Case Officer: Lewis Bankes-Hughes **Recommendation:** Approve

Applicant: Heyford Park Settlements LP

Proposal: Reserved Matters to 10/01642/OUT - Dorchester Phase 7B, comprising the provision of 6, two-bedroom and 3, three-bedroom affordable dwellings with associated landscaping, car parking, infrastructure and external works.

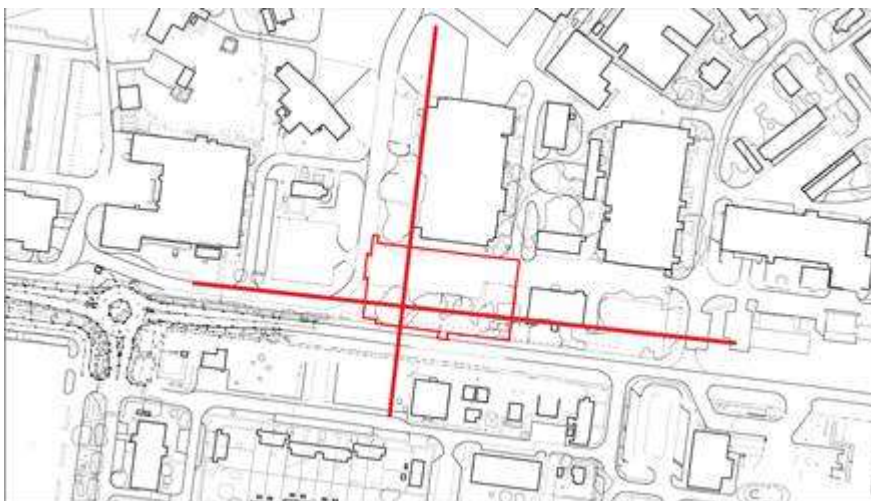
- Camp Road requires a strong building line in this location. A coherent building line has been created on the south side of the road, the character and appearance of the area would best be served if this is also reflected on the north side of the road as well. Camp Road needs 'presence', a layout which reflects the military past of the site. There are two strong building lines defined by the historic RAF buildings adjacent – shown on the plan below.

- The proposed development is disjointed and appears piecemeal; an apartment block would be far more acceptable in this location.

- There should be a coherent frontage to the highway.
- The two buildings in the NW corner of the plot are too close.
- The three buildings on the north side of the plot are too close to the hangar.
- There is a danger with the current layout that close board fencing will be a feature of the site.
- Retaining existing trees is to be encouraged but this should not be to the detriment of settlement development.
- The density of housing along Camp Road should be increased to meet the housing numbers specified. At no time should there be an assumption that building on the flying field 'because it is there and in common ownership' is acceptable as any such development has the potential to fundamentally undermine the significance of the site.
